**Re: Addendum #1 for ITB 21369 – A.J. Rickoff – Life Skills Academy – Range and Hood Installation**

This Addendum #1 reflects the following:

1 FIRST FLOOR PARTIAL ELECTRICAL PLAN  
E1.1 SCALE: 3/16" = 1'-0"

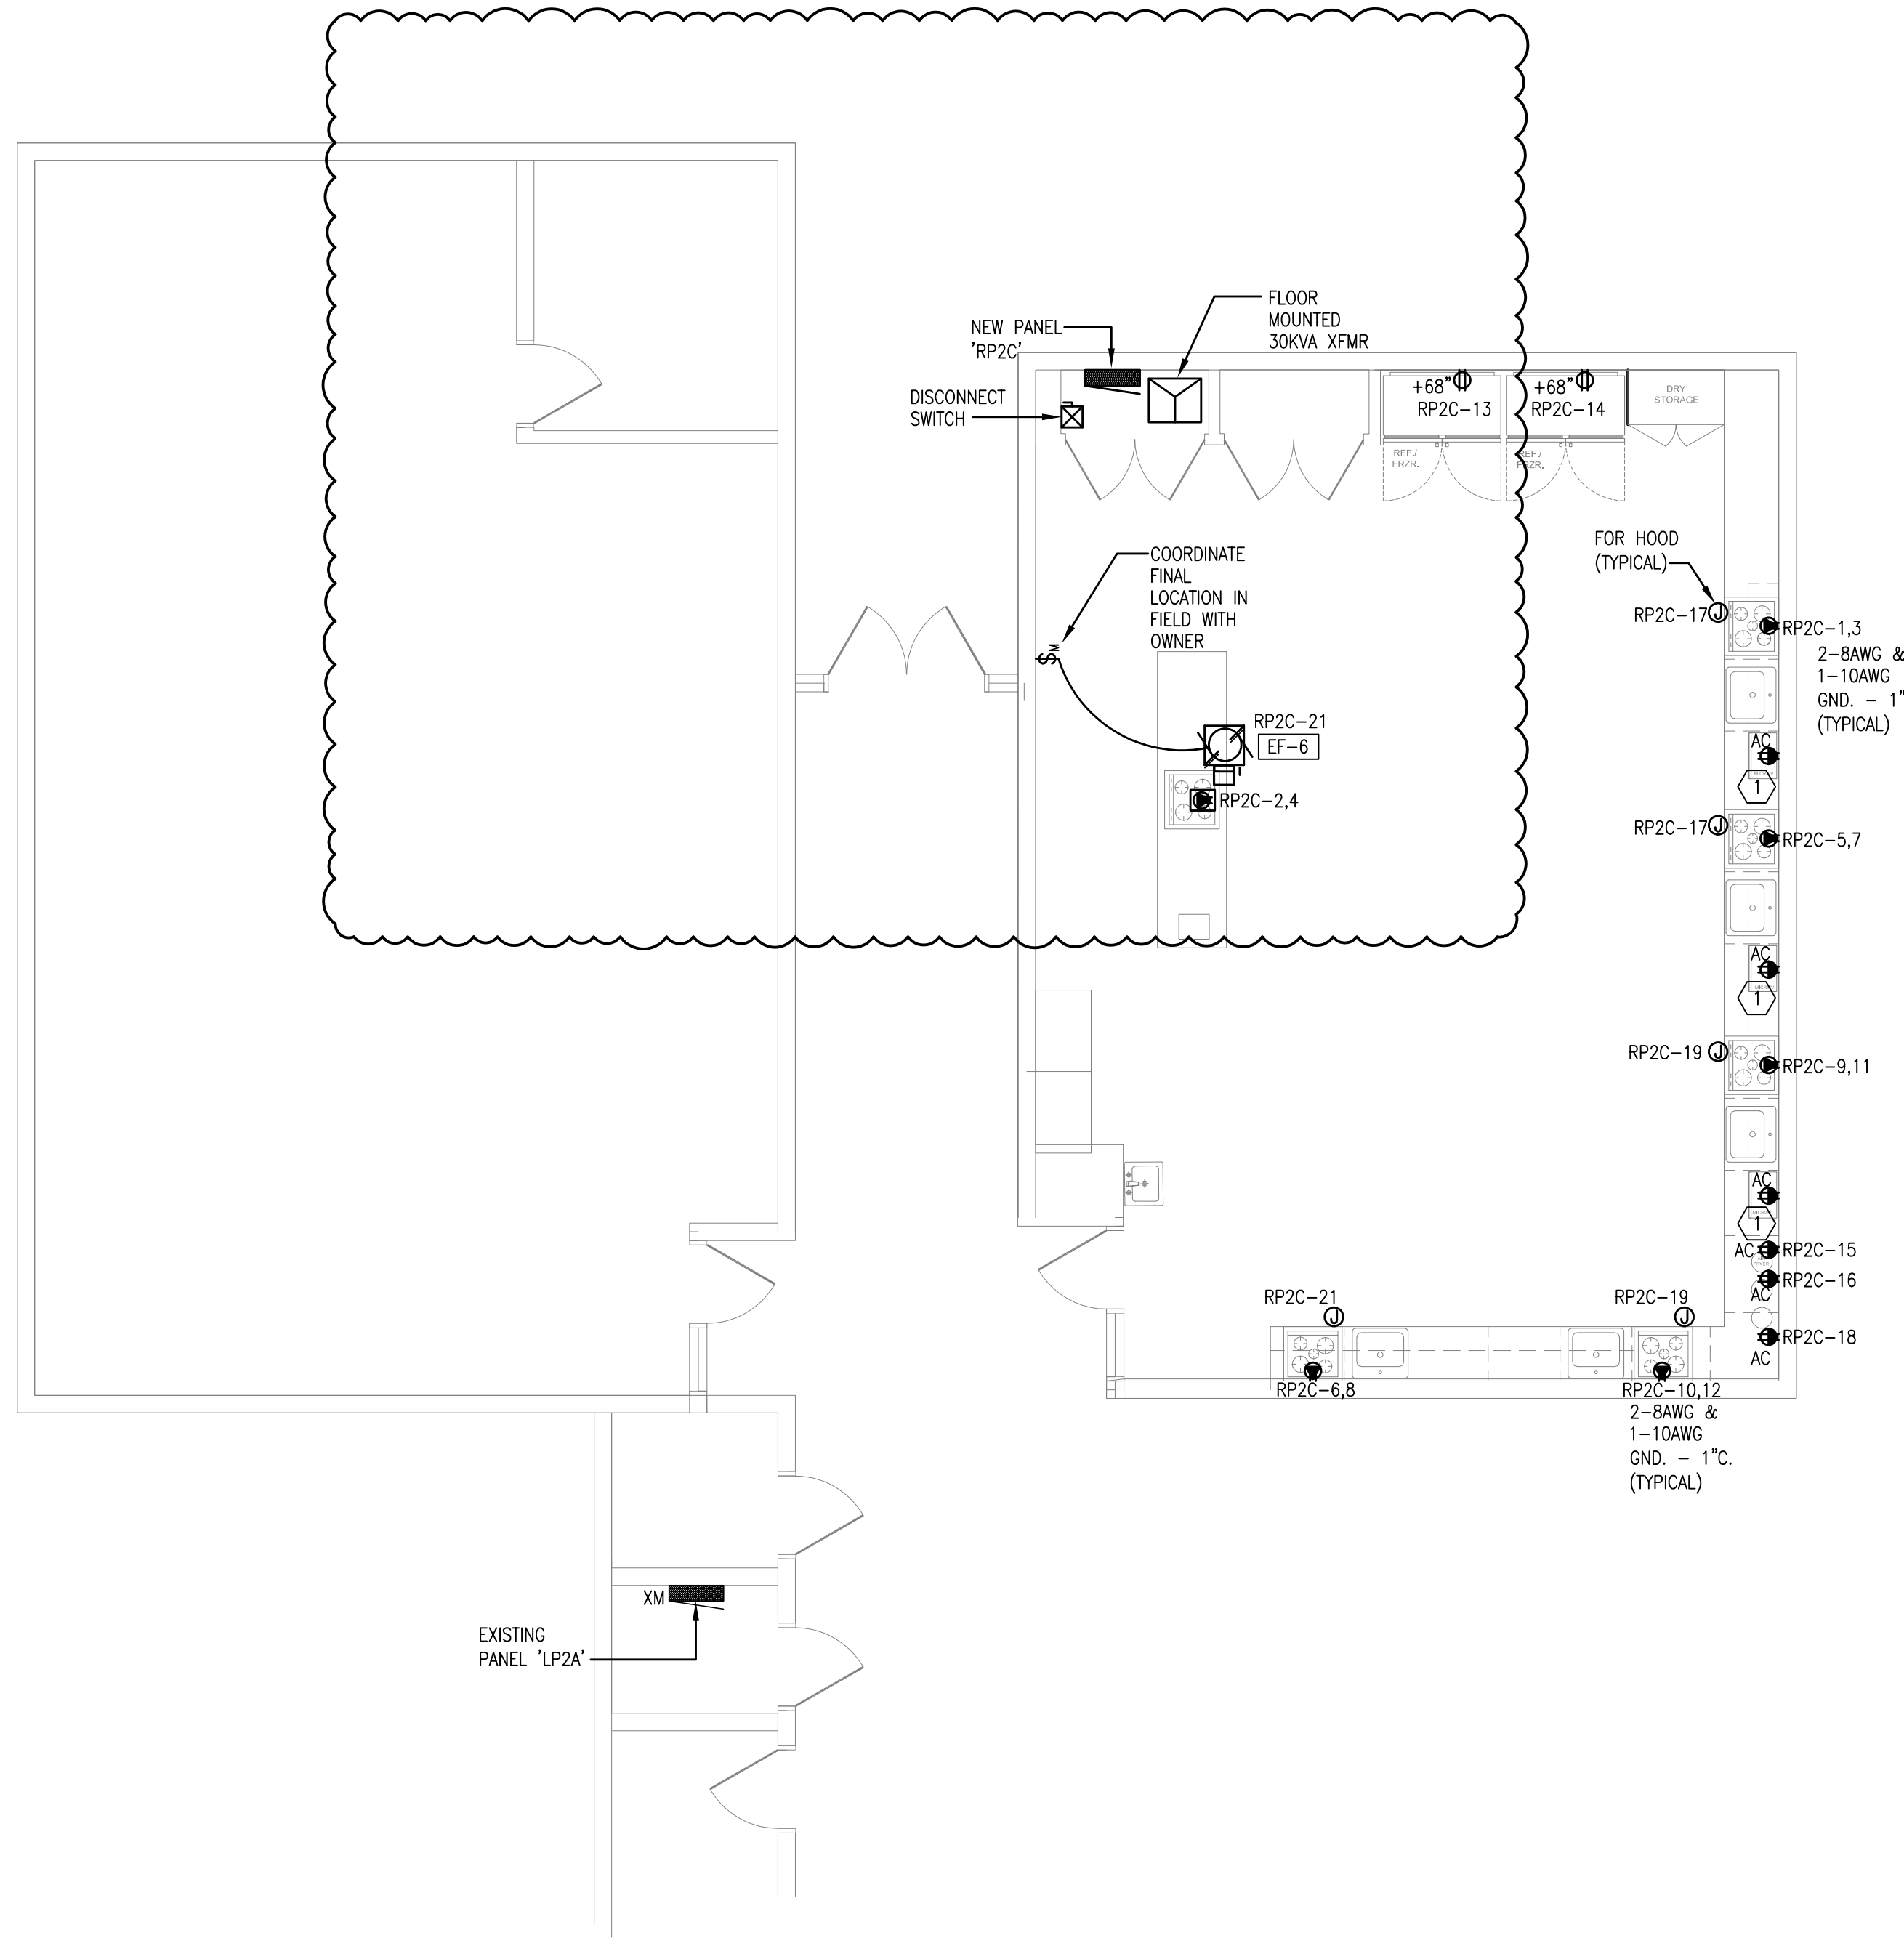
7. Please provide the location of the new location of the new electrical panel "RP2C", transformer, and disconnect. On drawing E1.1, it indicates the new electrical equipment being across the hallway from the life skills classroom. We found this space to be office spaces and seems to be strange place to install an electrical equipment?

See attached.
